PORT AUTHORITY OF ALLEGHENY COUNTY

SUBJECT: North Shore Connector
NSC Train Systems (System Wide)
Contract No. NSC-009

ADDENDUM NO. 5

September 5, 2008

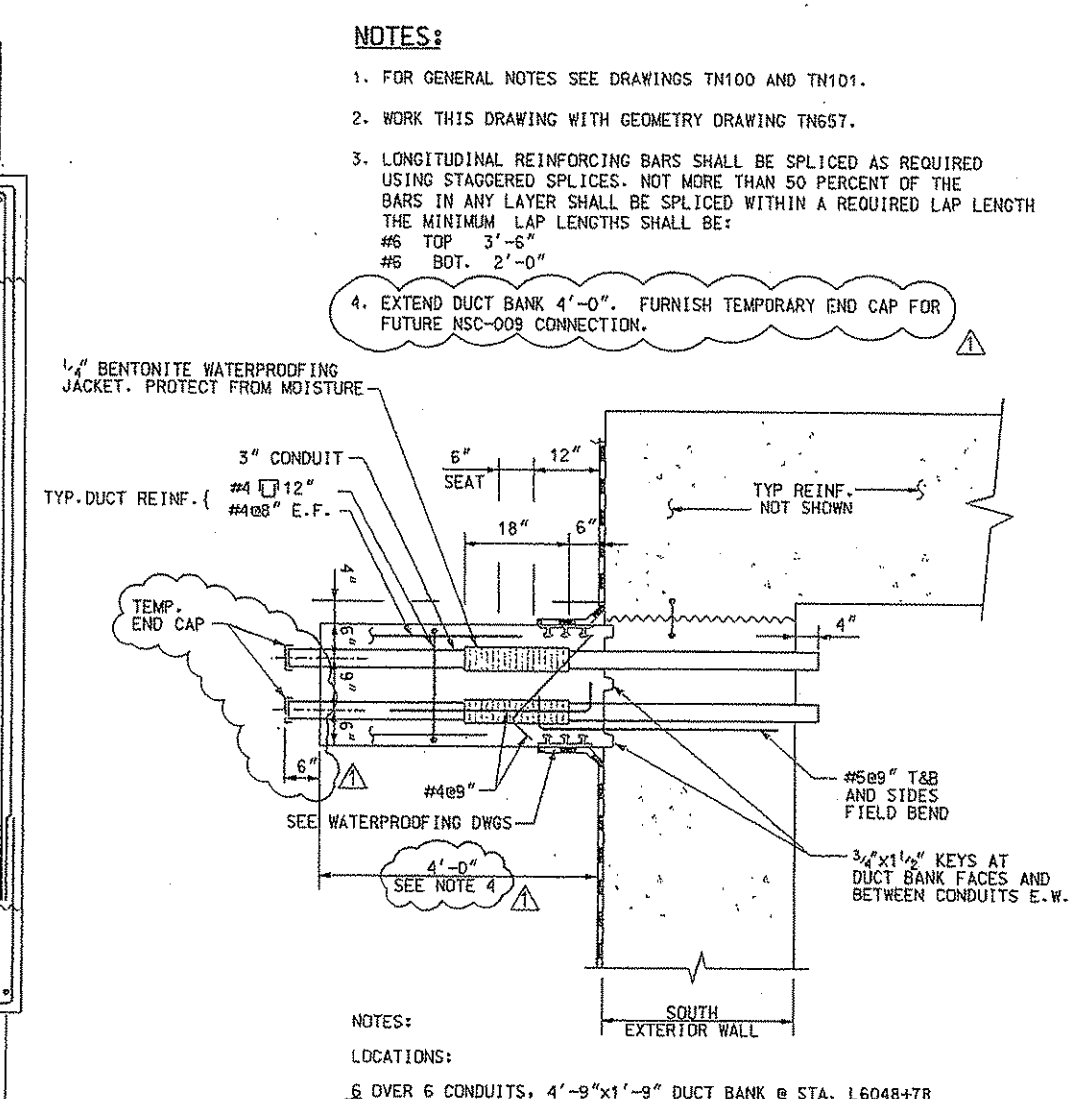
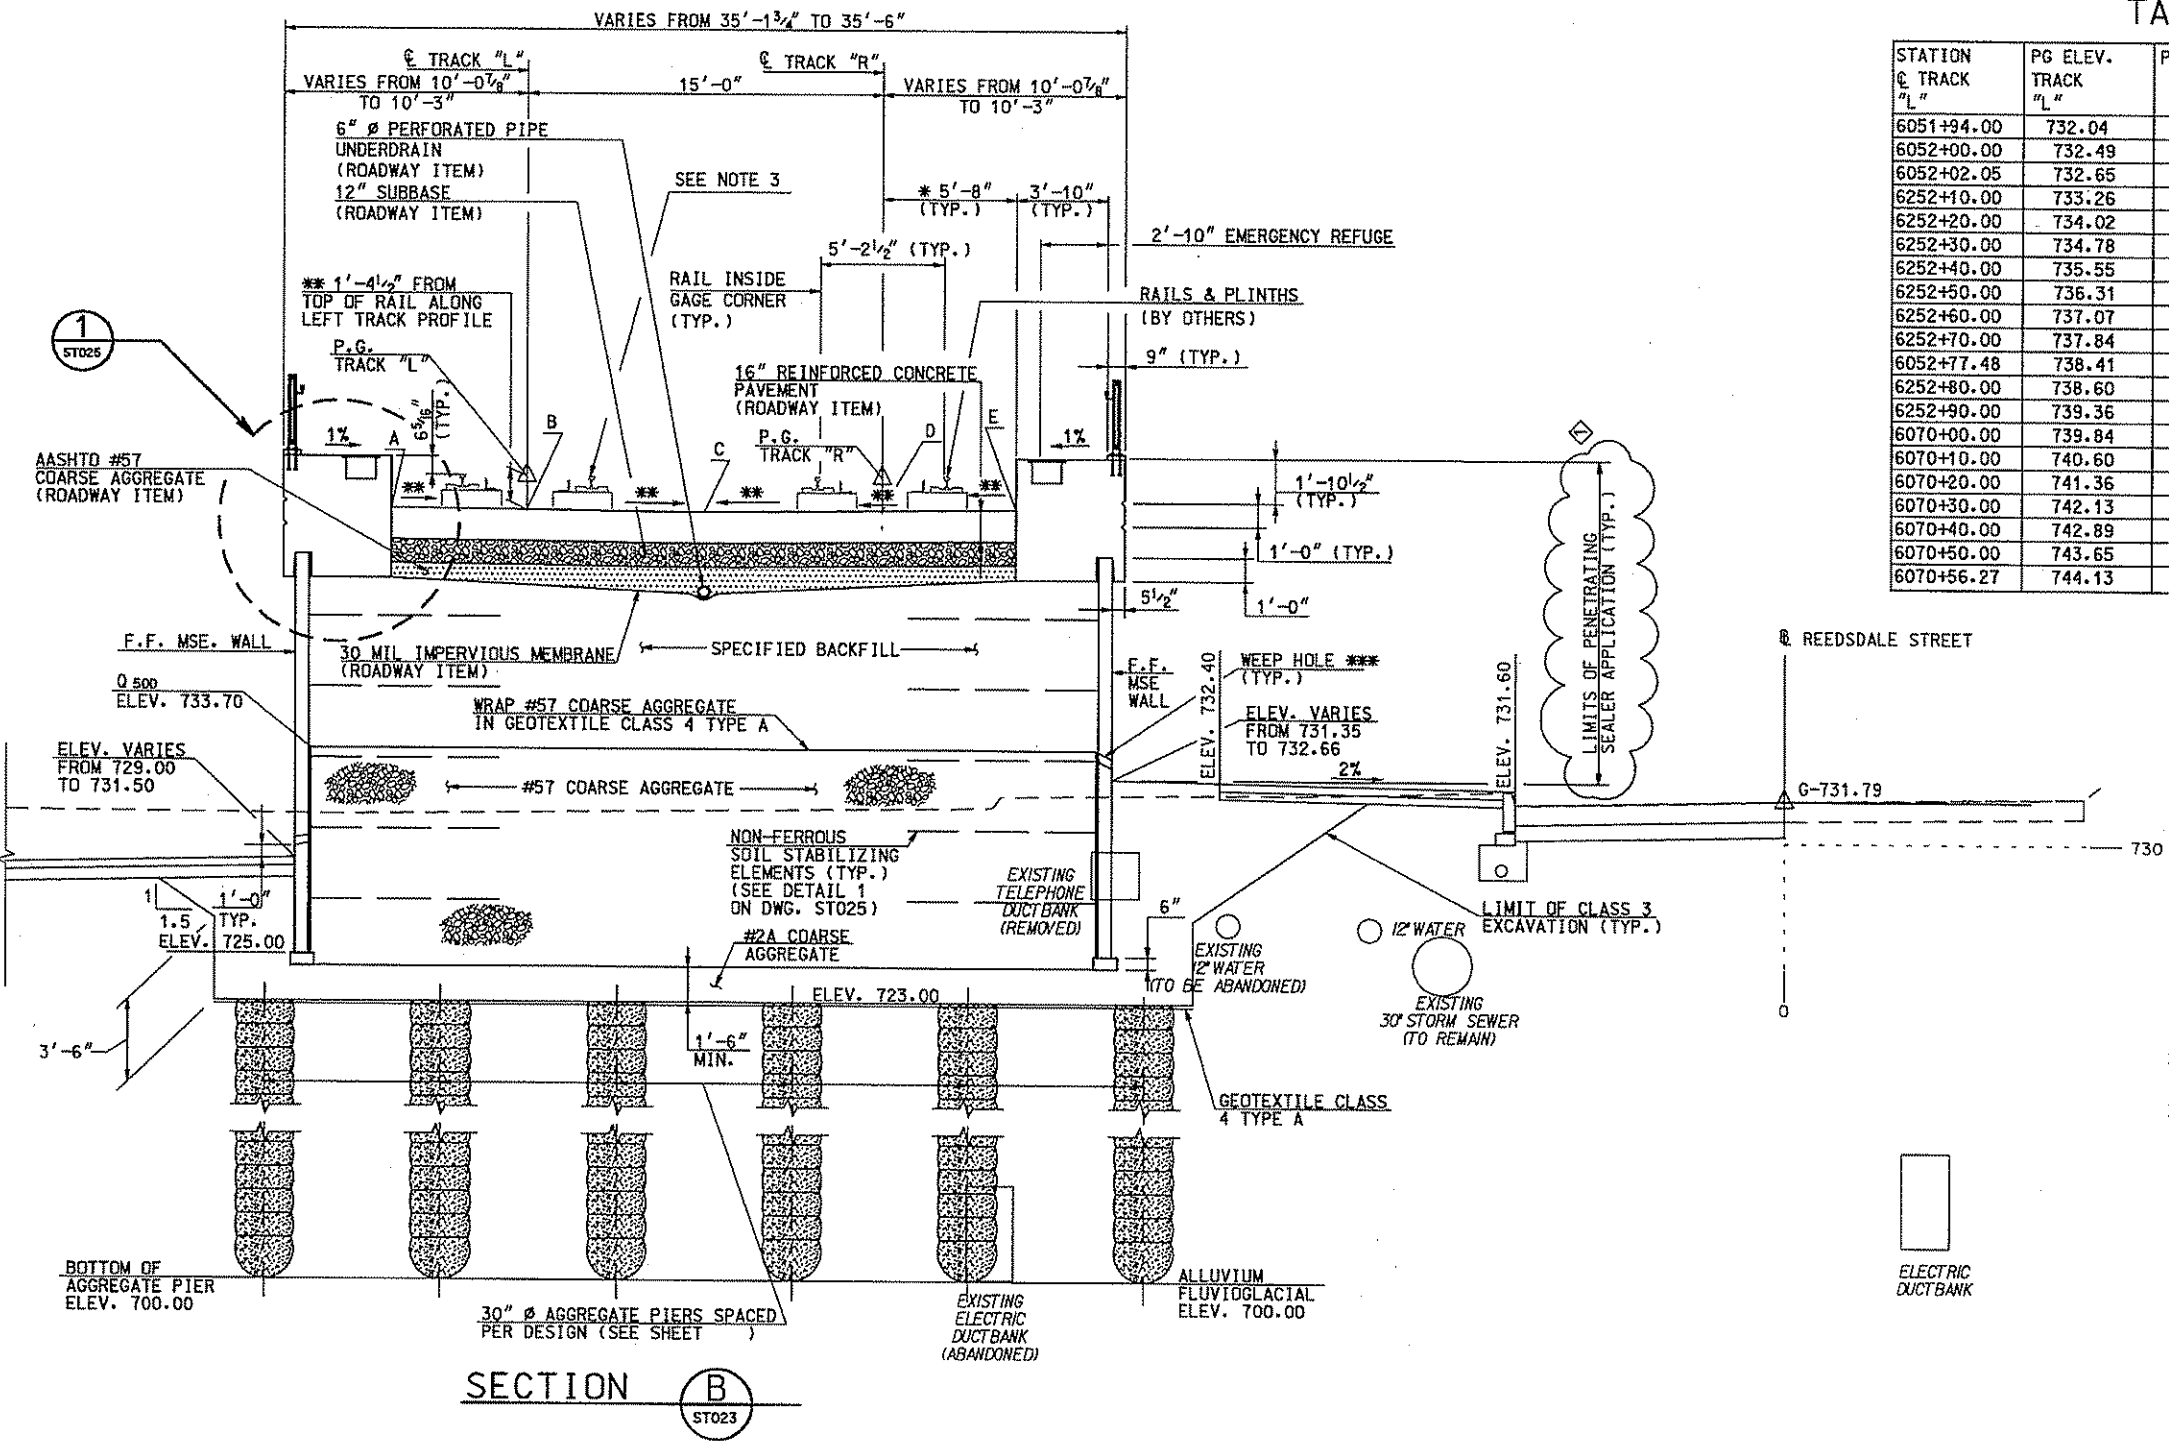
Question 143: Reference Dwg. CR206, Sift. 575 thru Dwg. CR208, Sht. 577

Response 143: Yes, See NSC-007 Drawing ST024 added in Addendum 5.
